Appeal to Portland Design Commission

LU – 19 – 249975 DZM

Elke Poehling

Map of Issues

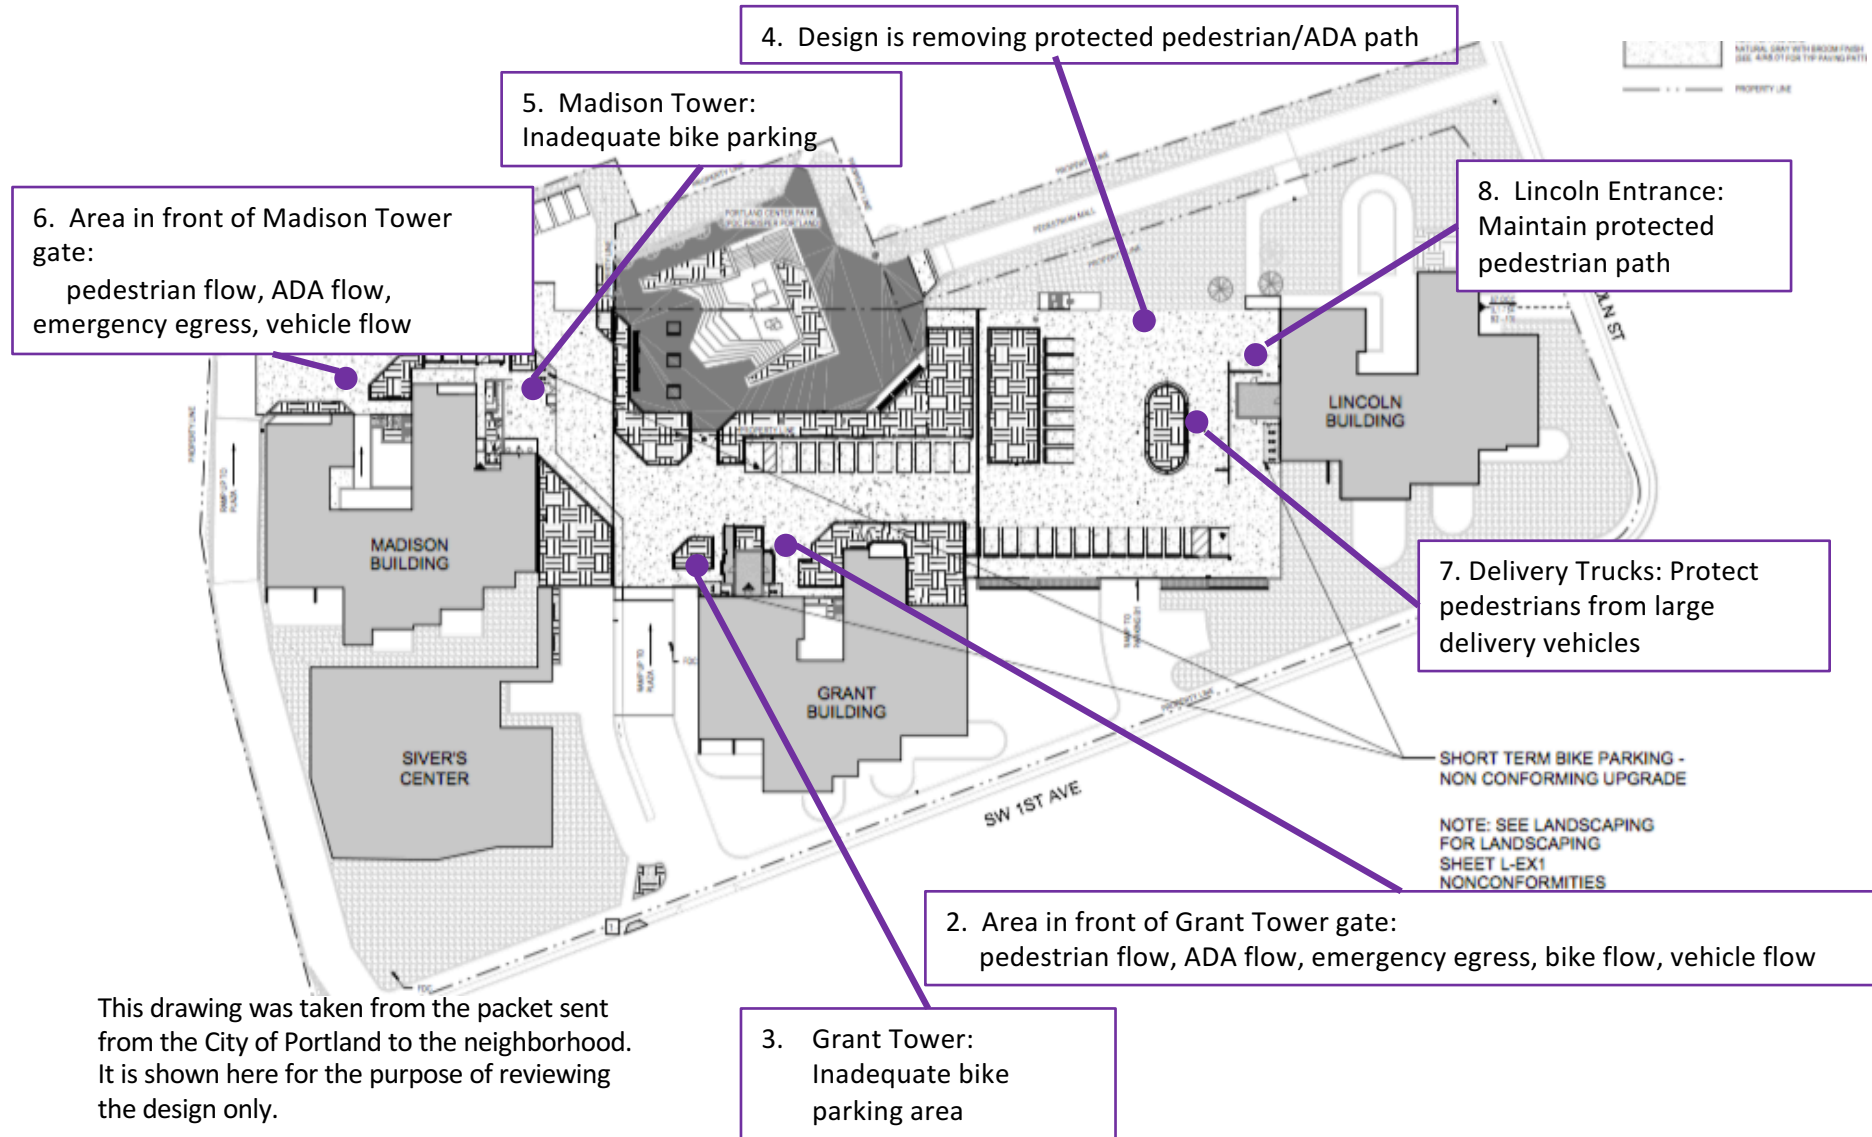
- 1. General: insufficient information provided to assess pedestrian flow

Issue #2: The Area in Front of the Grant Gate

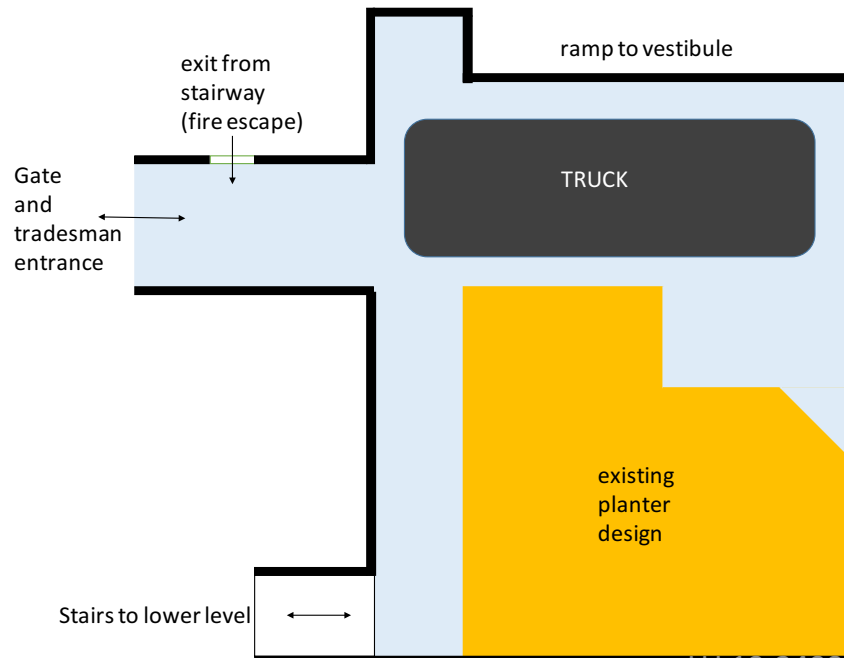
This area works well, until someone is using the loading zone...

Now the >12 foot passage is reduced to below the required 44 inches of a pedestrian path

And, it is definitely NOT a PROTECTED pedestrian path

Fire Exit Discharge

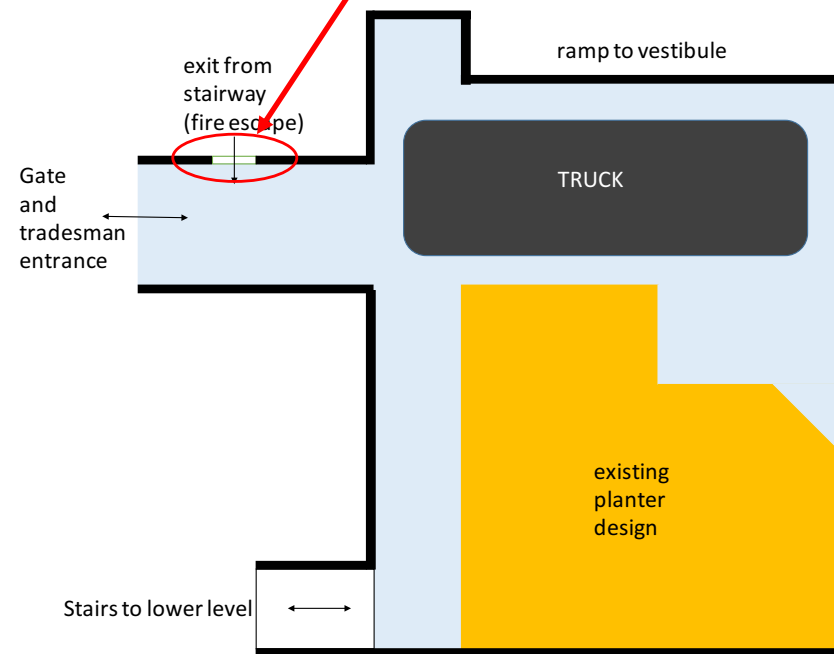
Floors 2 through 26 all have EXIT signs leading to the fire escape stairway shown. The stairway exits into the **area in front of the Grant gate.**

All is well if there is no vehicle.
But, what if there is...

The area outside of the Grant gate is not 50 feet from the building

When a vehicle is in the loading zone, the passage width can be less than 44 inches; the means of egress has been reduced.

As designed, this area cannot be used for both a loading zone and a fire exit discharge. The design needs to be changed.

Emergency Medical Response

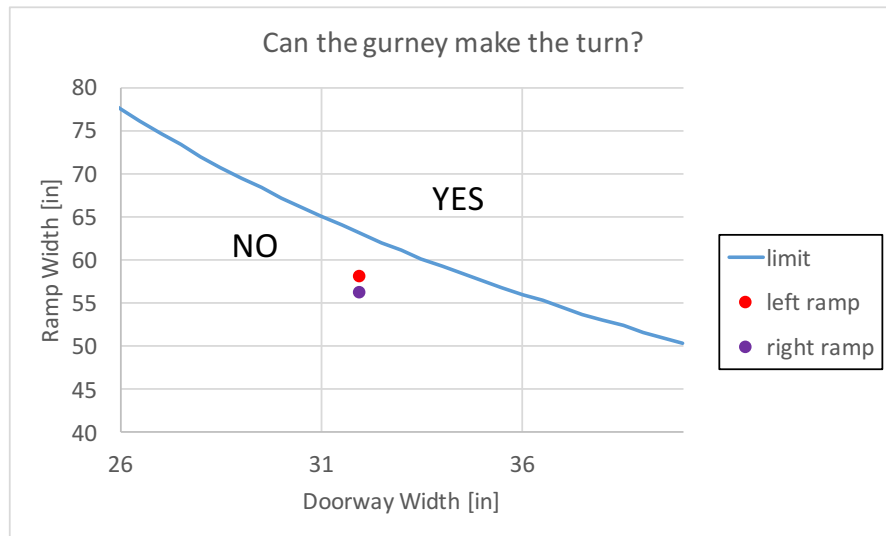
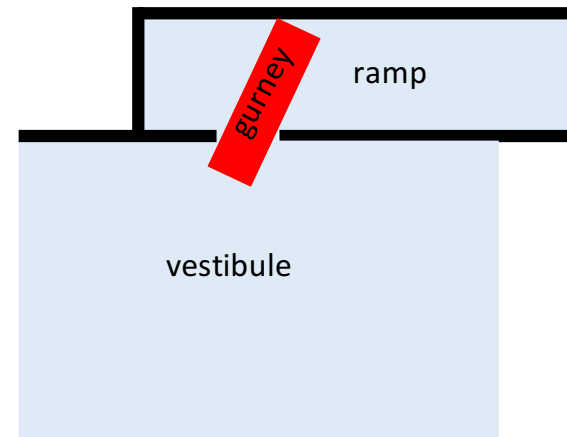
If a vehicle is blocking path from the gate, can a patient be evacuated through the lobby?

An EMT gurney is 84" X 24".

The vestibule door is 32"

Our current design is comfortably on the NO side of the limit: A gurney cannot make the turn out of the vestibule.

So, the lobby is not a possible alternate route. This is not a legal code, it is just geometry.

The area **outside the Grant gate** is THE way out of Grant Tower for medical response. It needs to be unblocked (Central City Guidelines II.B.7)

Issue #3: Grant Tower, Short-Term Bicycle Parking

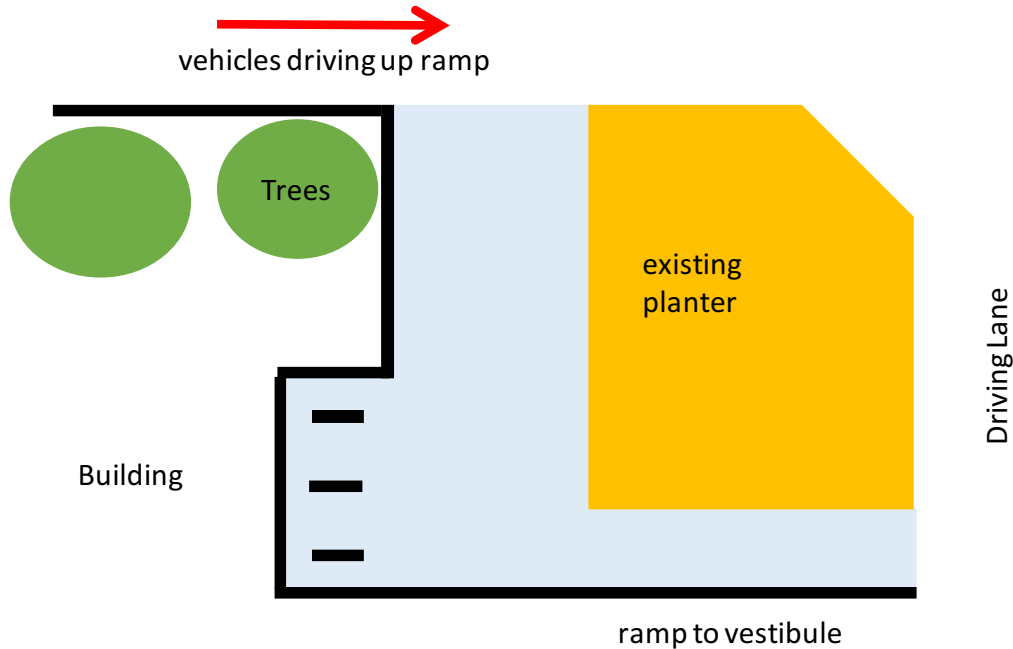
Current bicycle parking outside of Grant Tower

Currently there are 3 racks to the south of the vestibule (opposite side of the vestibule as the gate).

The plan is to re-install the bike racks and planter the same way.

But, that plan does not meet today's standards (33.266)

Current Design

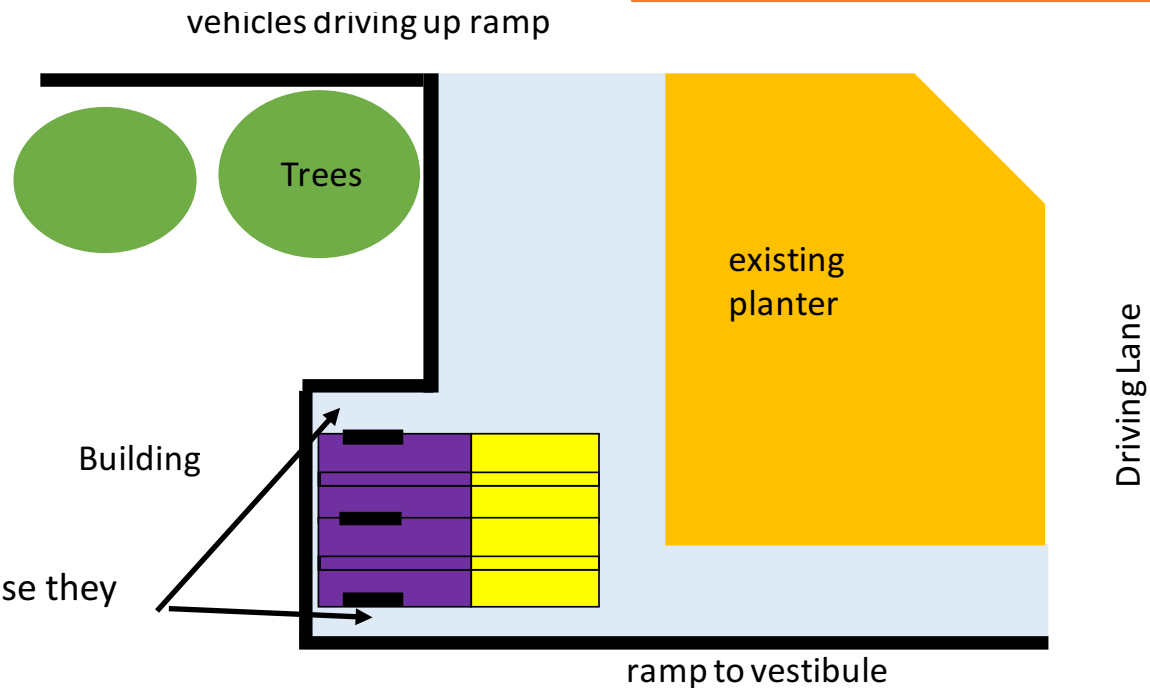
The available width where the bike racks are located is 10 feet

Width needed for 3 racks / 6 bikes per old standard (applicable to this design)	$2' + 4' + 4' + 2' = 12$ feet
Width needed for 3 racks / 6 bikes per new standard	$2\frac{1}{2}' + 3' + 3' + 2\frac{1}{2}' = 11$ feet
Available width in the current design	10 feet (not enough for 3 racks / 6 bikes)

Drawn per the new standard
Only 4 bike spaces fit.

That means that the current design can only accommodate 4 bike parking spaces, even though there are three racks.

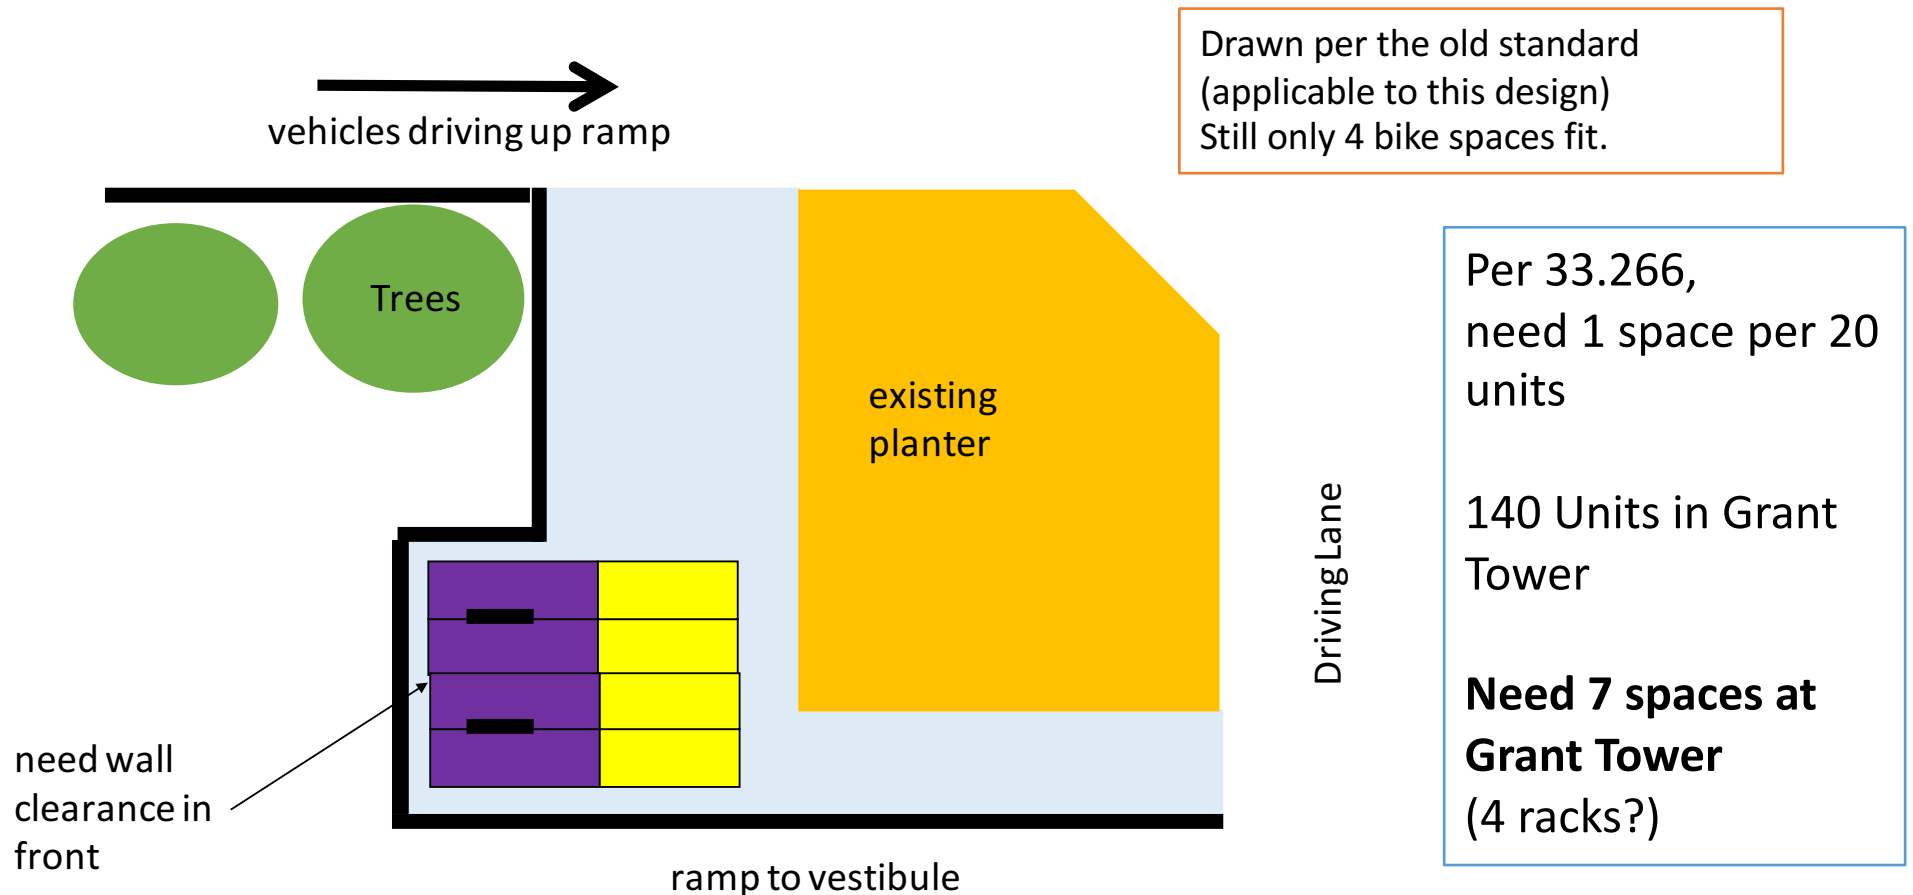
This is the best we can do, even if we adopt the more lenient new standard

cannot use these areas because they are less than $2\frac{1}{2}$ ft wide

So, this area is insufficient. We need more racks somewhere else.
And, there are other things wrong with the current design...

The area can be redesigned with 2 racks to fit 4 bikes (why buy 3 racks?)

Visibility

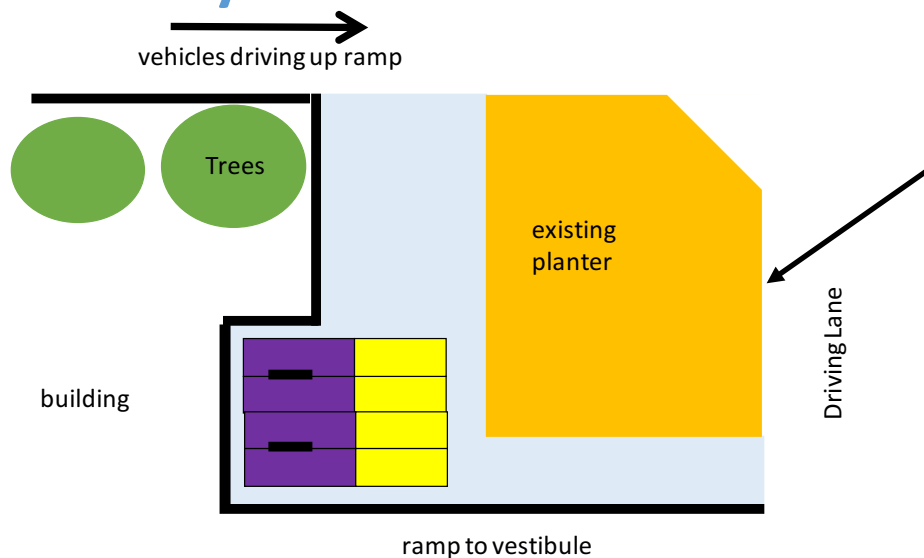
The current location is not “highly visible”, arguably not even “visible.”

These racks were installed in 2006 with the expressed intent of being non-visible.

The land usage design of the Plaza needs to be changed: bring the racks into the open

Access to Existing Bike Parking Area is Not Designed as a Bike Path

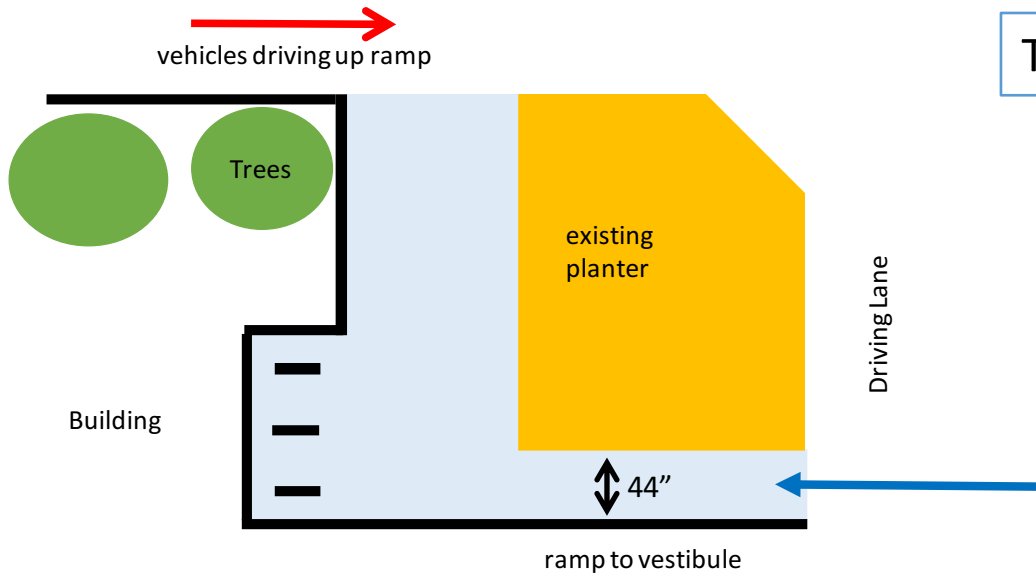
This is a poor flow design for bicycles

This passageway is 44" wide (minimum width for a protected pedestrian path) too narrow for bicycle access.

Minimum recommended width for a 1-way bike lane is 48"
Recommended width is 60" (smallest size I could find on any City of Portland website)

This passage should be wider, if bikes are to be parked in this area.

Safety (Blind Exit)

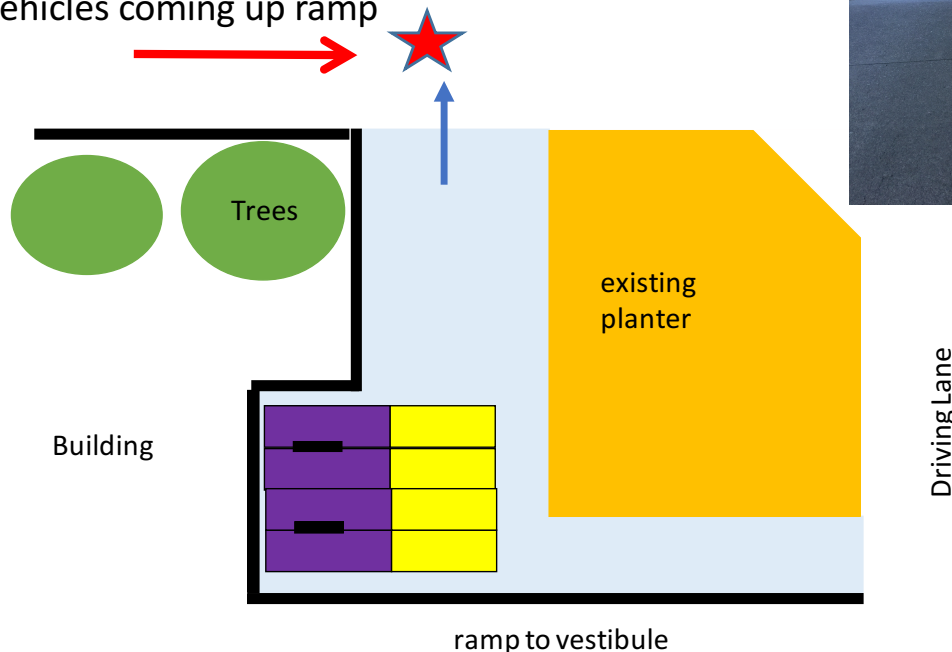
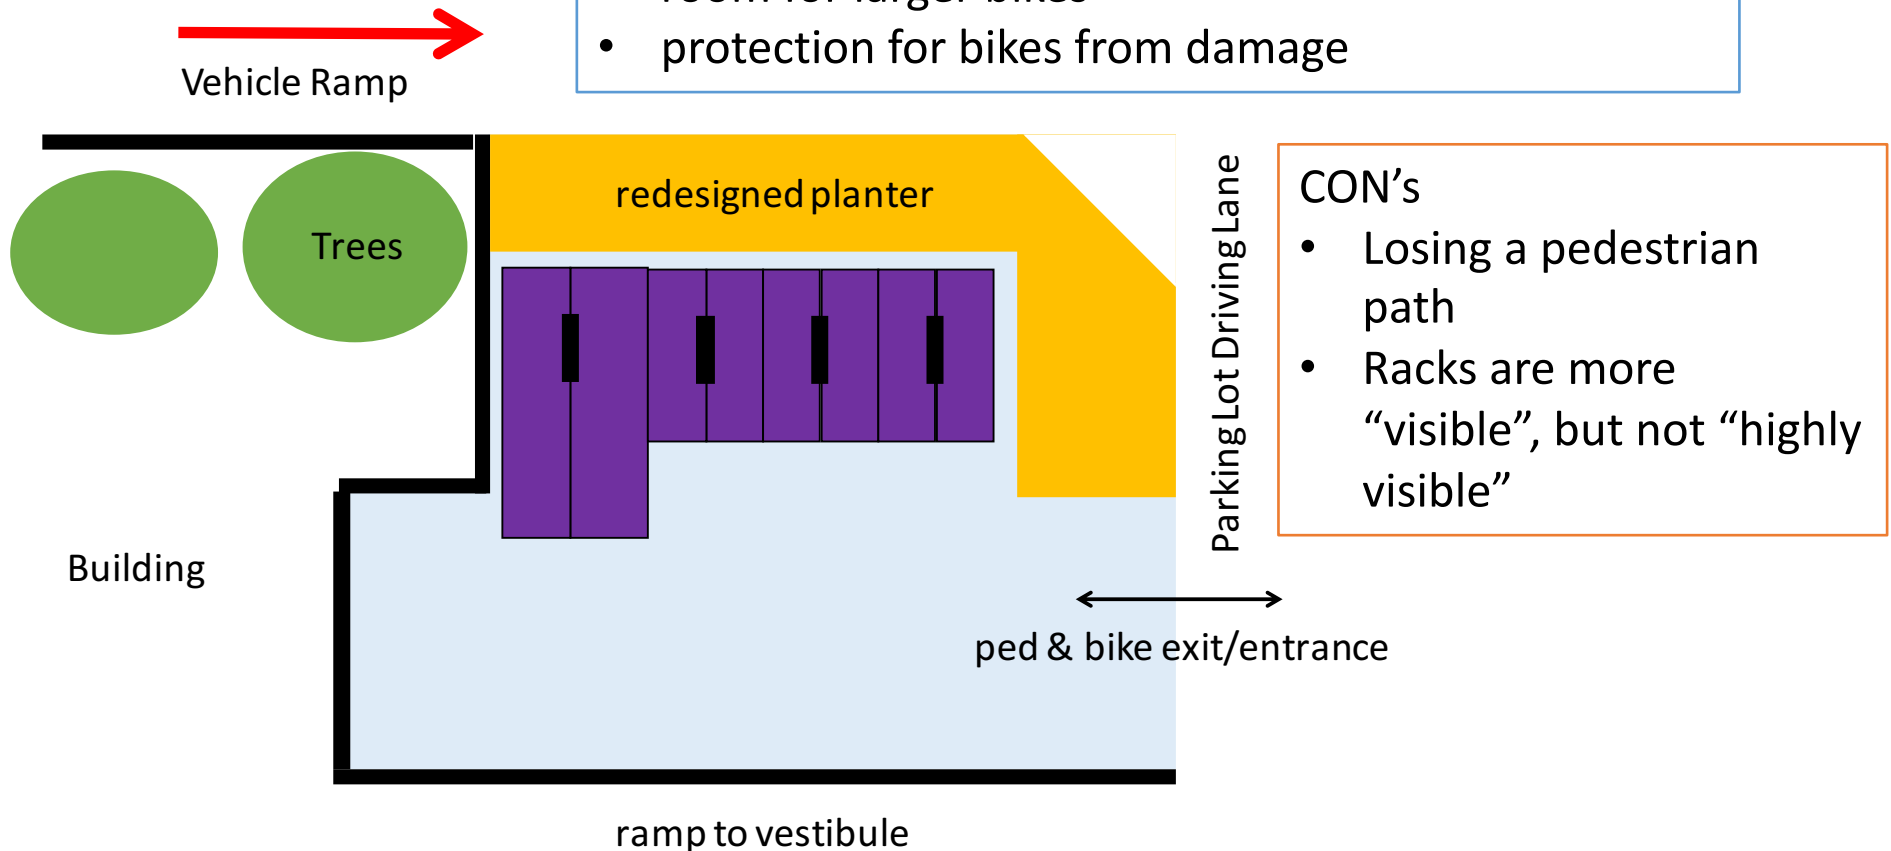
- 2-way traffic, so cars will be on right side of ramp
- moving faster than in parking lot
- not expecting a bike to exit
- cannot see bike (trees and building)

- cannot see bikes exiting

- cannot see cars (trees and building)

If this area is used for bike parking, the design needs to be changed
